MOTOROLA

MC68341

ADDENDUM TO MC68341 Integrated Processor User's Manual

April 19, 1995

Figure 3-12. M68300 Write Cycle timing

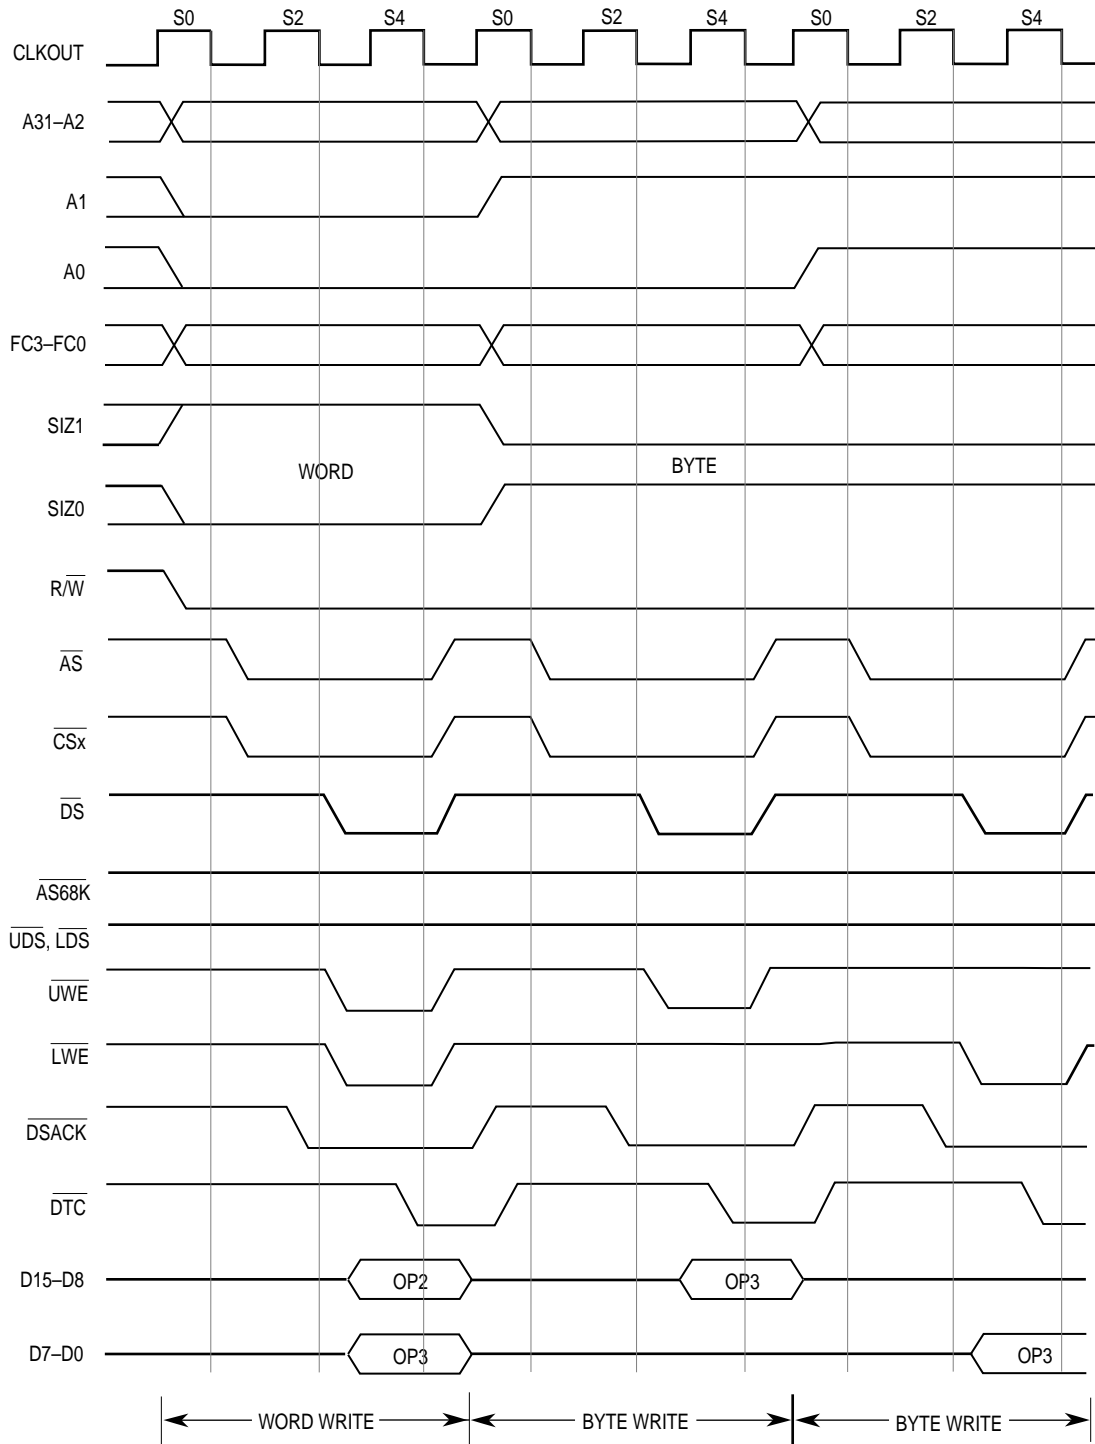
On page 3-25, the M68300 write cycle timing diagram (Figure 3-12) shows incorrect timing for \overline{DS} , \overline{UWE} , and \overline{LWE} . On page 3-28, the M68000 write cycle timing diagram (Figure 3-14) shows incorrect timing for $\overline{AS68K}$, \overline{CSx} , $\overline{UDS/LDS}$, and $\overline{UWE/LWE}$. Replace these figures with the following corrected figures.

Figure 11-2. Sample Crystal Circuit

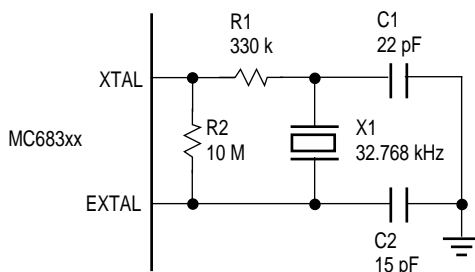
On page 11-2, Figure 11-2, a 10M resistor can be substituted for the 20M R2 bias resistor as shown below.

Figure 11-14. Circuit For Interfacing 8-Bit Device to 16-Bit Memory in Single-Address DMA Mode

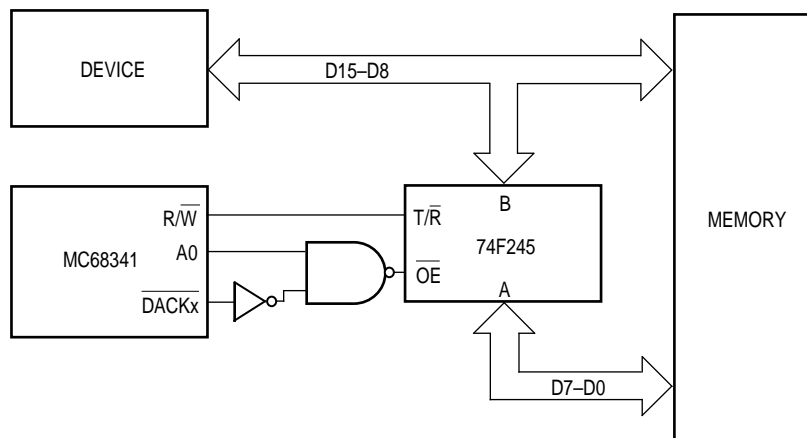
On page 11-10, the logic driving \overline{OE} on the 74F245 in Figure 11-14 should be corrected as shown below. Although not detailed, the byte enables for the memory block should be controlled during reads to prevent contention between the upper and lower bytes of the data bus when D7-D0 is muxed to the upper data byte.

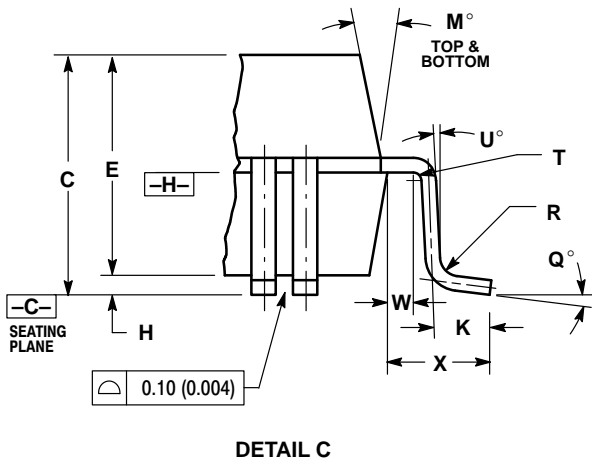
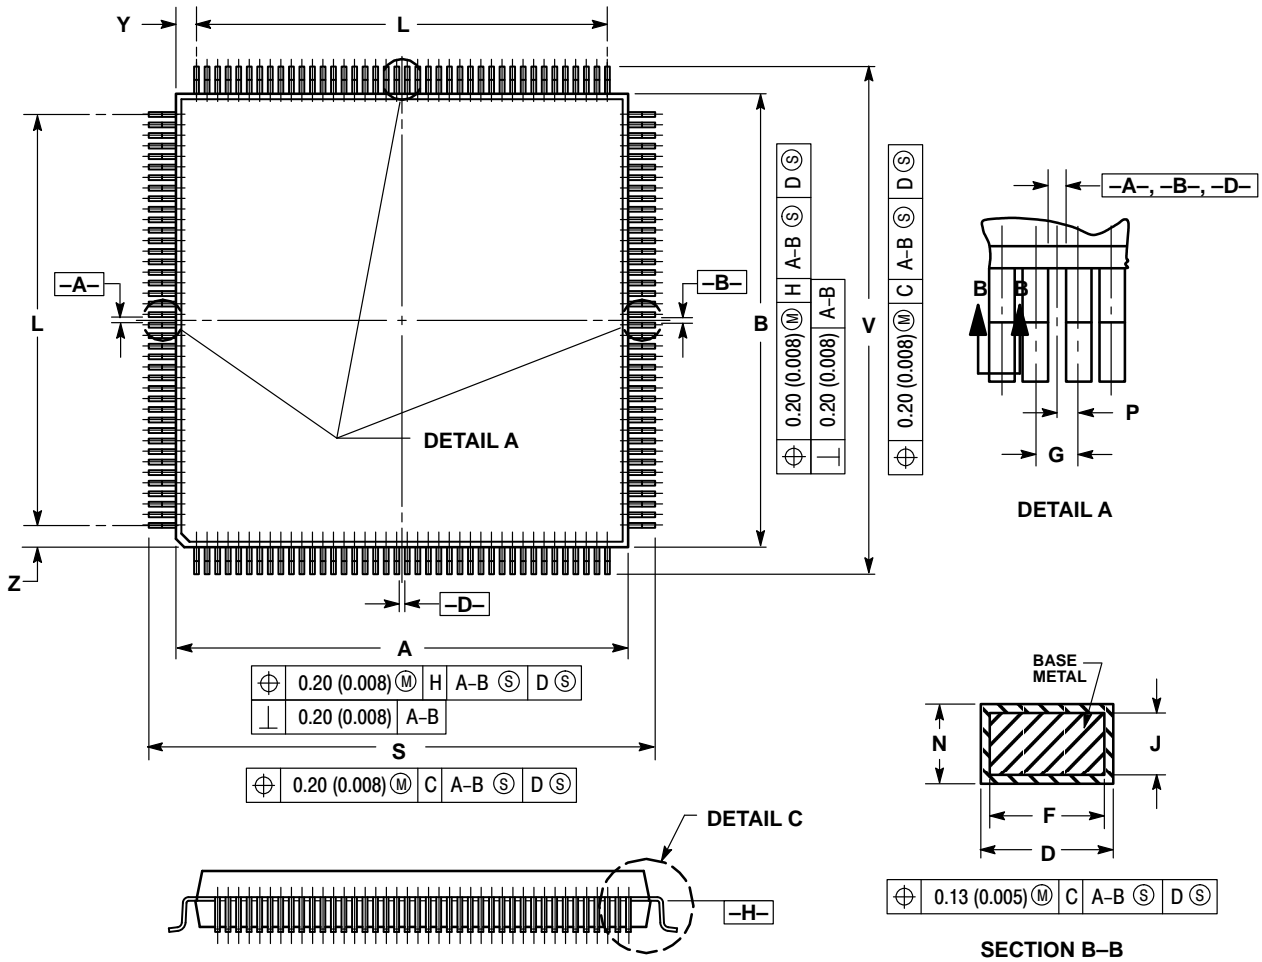
The package dimension drawing on page 13-3 should be discarded and replaced with the following drawing.
